**TOWN OF NEWBURGH
PLANNING BOARD
TECHNICAL REVIEW COMMENTS**

PROJECT NAME: KINGDOM HALL
PROJECT NO.: 22-31
PROJECT LOCATION: 33 OLD LITTLE BRITAIN RD
SECTION 97, BLOCK 3, LOT 13
REVIEW DATE: 9 JUNE 2023
MEETING DATE: 15 JUNE 2023
PROJECT REPRESENTATIVE: GREENMAN – PEDERSEN, INC

Re: **Jehovah's Witnesses 220 Seat New Kingdom Hall**
33 Old Little Britain Road, Newburgh, NY
Town of Newburgh Planning Board
MHE Engineering – Response to Technical Review Comments Issued 12 May 2023
KALA – Response to Technical Review Comments Issued 12 May 2023

SHEET No. **CU101**

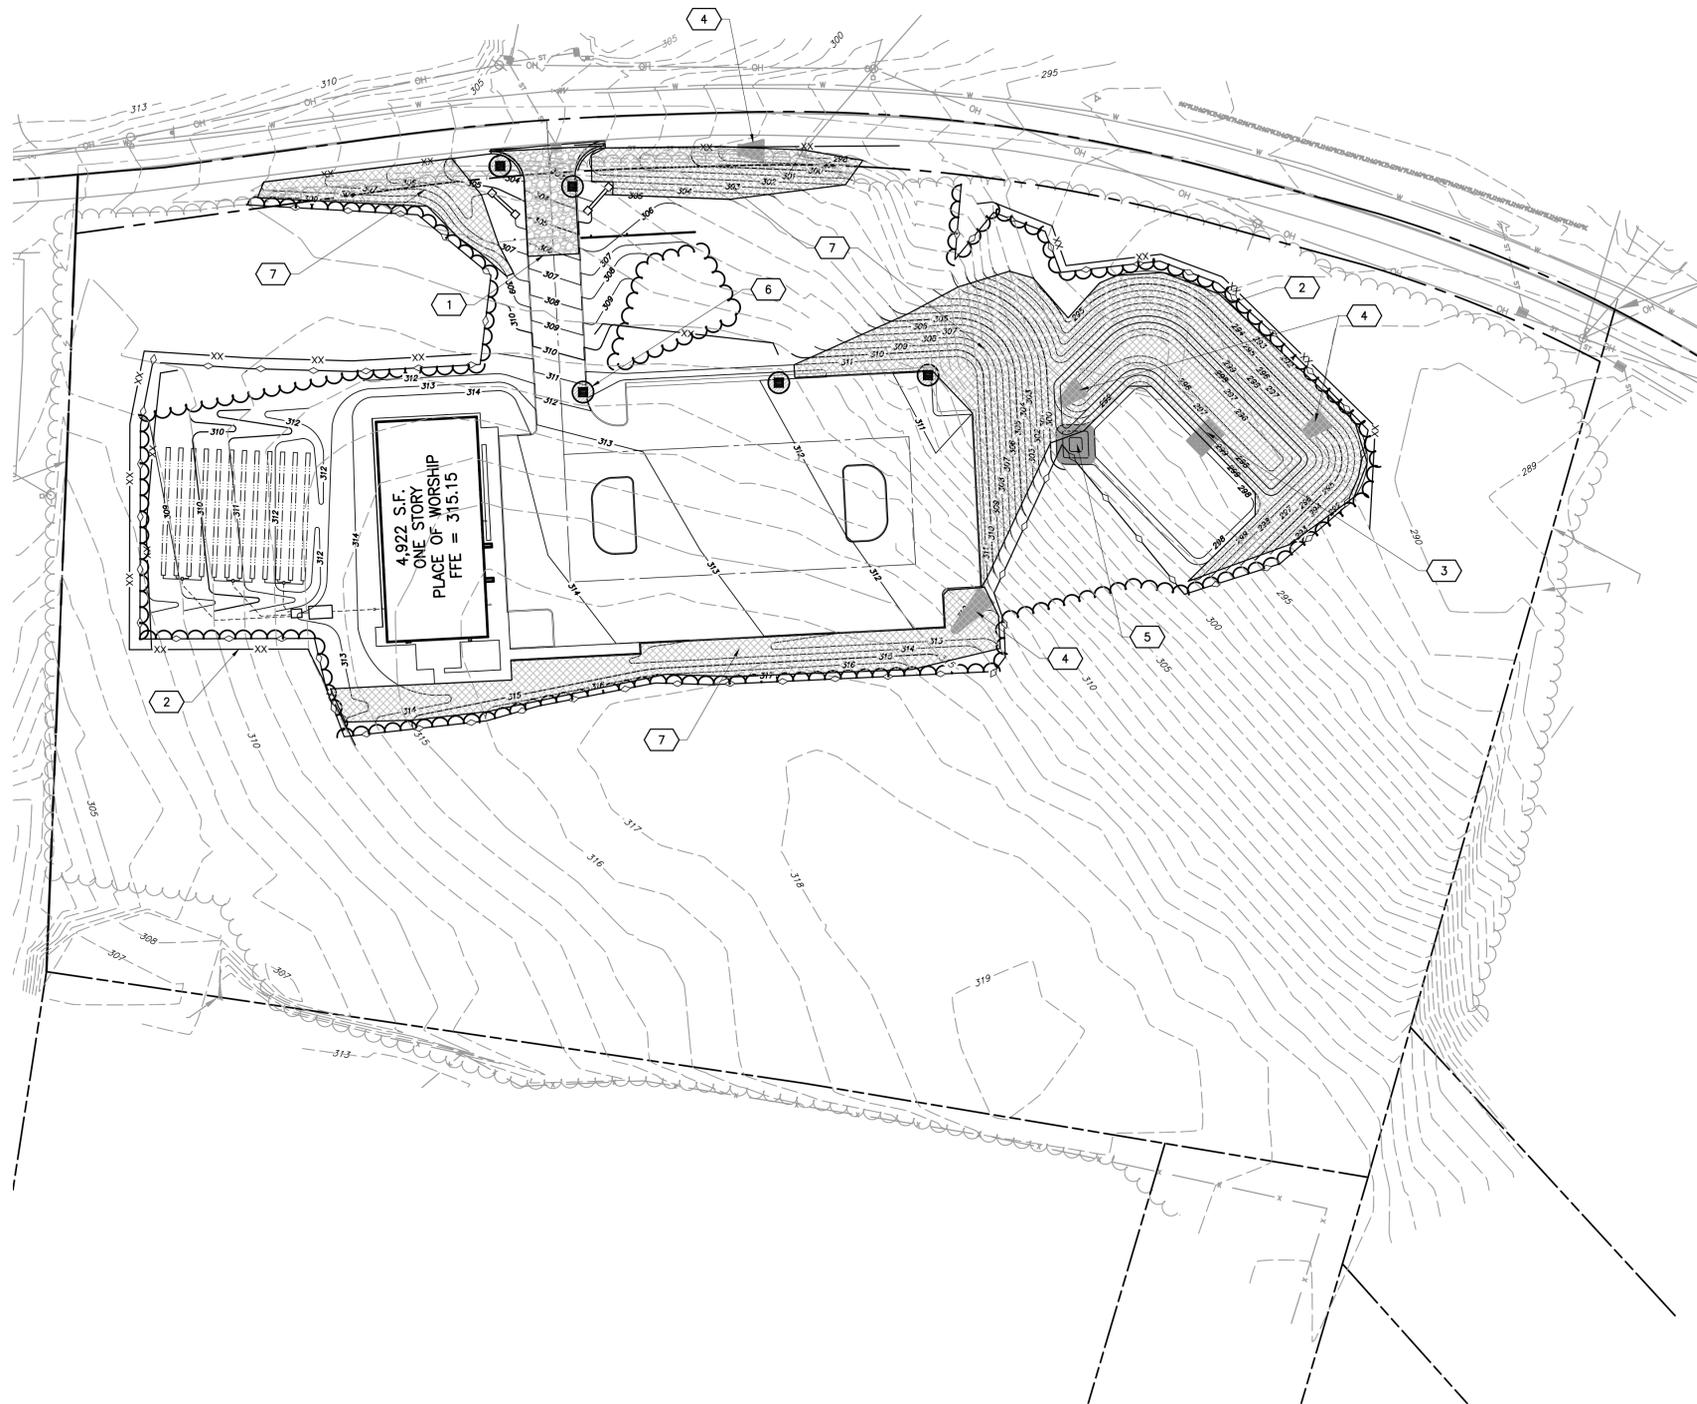
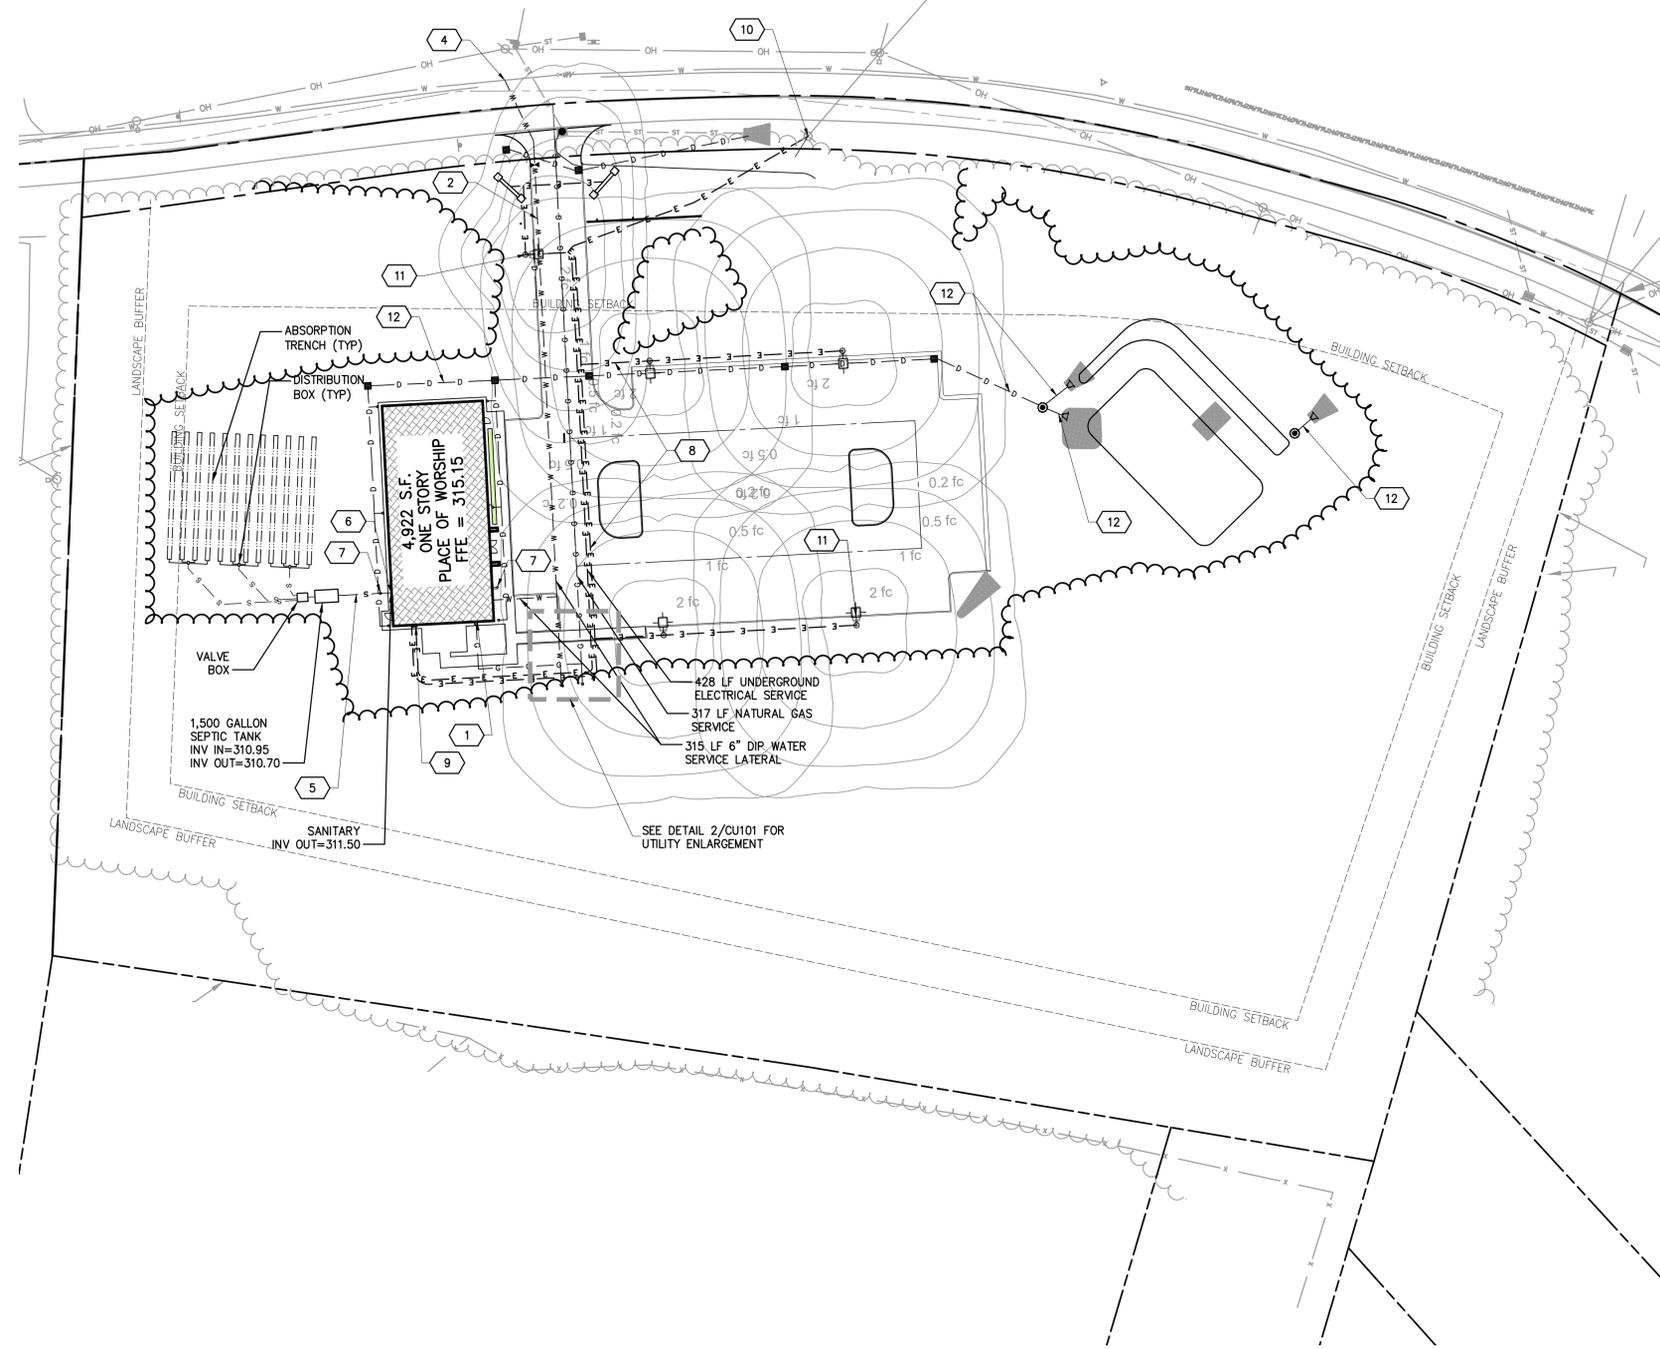
4. The septic tank is labeled as 1.2 gallon tank on Sheet CU-101. This should be labeled 1,500 gallons per other plan details.
 - *The septic tank label has been updated on Sheet CU-101.*

SHEET No. **LP101**

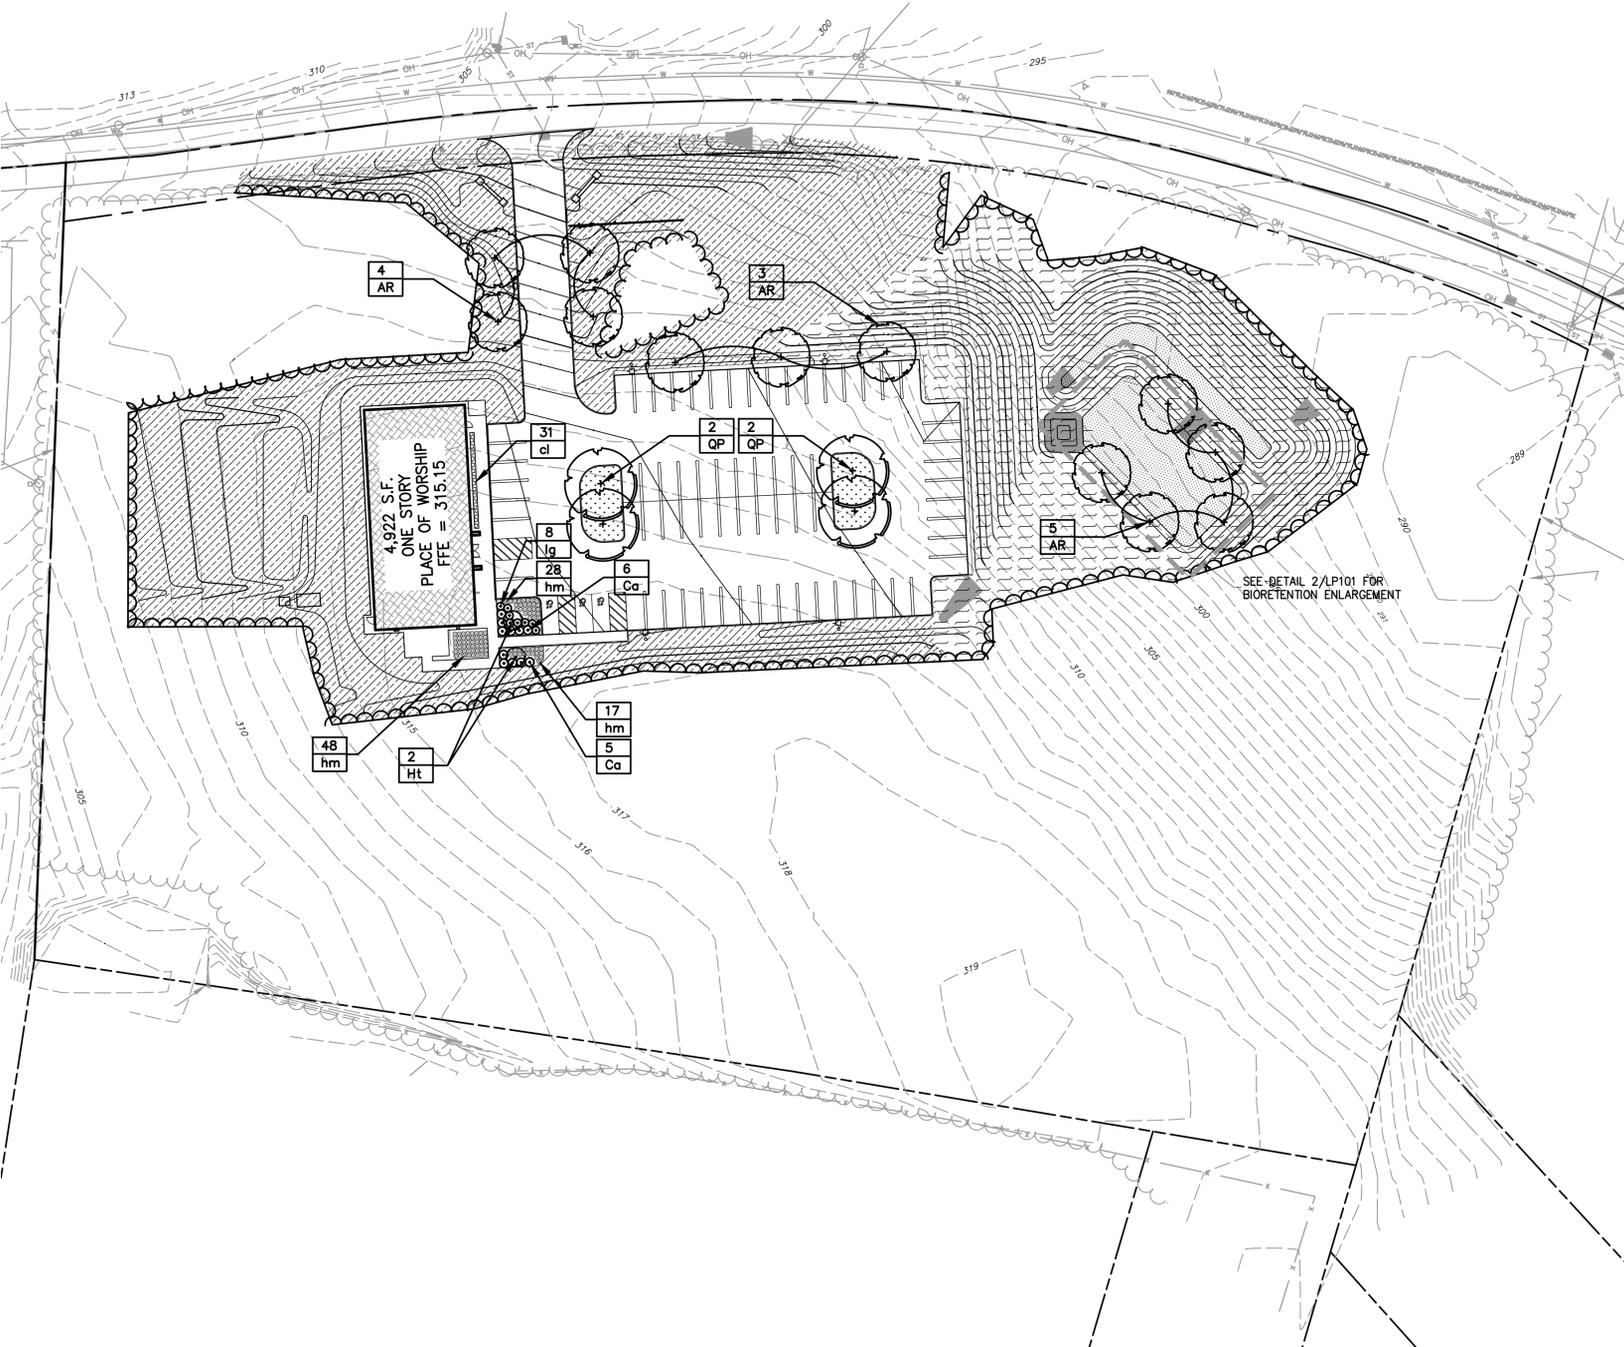
3. Multiple types of groundcovers are shown and quantified in the Ground Cover Legend but it is unclear where any of the groundcovers aside from grass are proposed on this plan. A monoculture of grass provides very little ecological benefit. On the slopes of the infiltration basin, specify Pinelands Nursey Basin Slope Mix (ZXMIXBASSL) and at the bottom of the infiltration basin, specify Pinelands Nursey Basin Bottom Mix (ZXMIXBASBO). This will increase biodiversity on the site, reduce maintenance, and fill in empty spaces between proposed basin plantings

4. The stormwater management area is approximately 75'x250', with plenty of space to add trees. Propose at least five Red Maples or 8 Shadblow Serviceberry in the stormwater management area.

5. A large, steep hill is proposed on the northeast corner of the proposed parking lot. Lawn will not be sufficient to reduce potential erosion on this slope and will not provide ecological benefits to the site. Instead, show Pinelands Nursery Erosion Control Mix (ZXMIXEROSC) on the whole hill to provide food and habitat for local wildlife and to reduce erosion along the hill. This will also reduce maintenance costs as it needs mowing only once or twice a year.

6. To avoid parking islands full of messy mulch, fill the islands beneath the Oaks with Gro Low Sumac or a low/no mow seed mix such as PT 769 R&R Eco-Turf Mix with Microclover or PT 702 Let it Bee. This also provide a nice, green color in the parking area.
 - *PT 702 Let it Bee seed mix has been noted for the parking lot islands.*

- *Per the tree preservation regulations, the project remains under the percentage removal that would require compensatory tree plantings or compensation. However, the owner has decided to add the five Red Maples. The eight serviceberry trees have not been added.*

12 DETAIL - ENTRANCE WALL AND MONUMENT SIGN

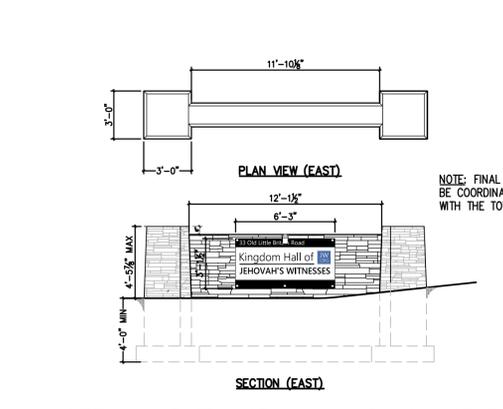
1. Provide details of the stone entry walls with the monument signs Please design the walls in accordance with Town of Newburgh design guidelines.

- *The stone entry wall with sign detail has been added to sheet C-502 – Detail # 12. The detail also notes that the final design of the sign will be coordinated with the Town and we ask that the sign permit and final design of the sign be noted as an action that will be pursued after site plan approval.*
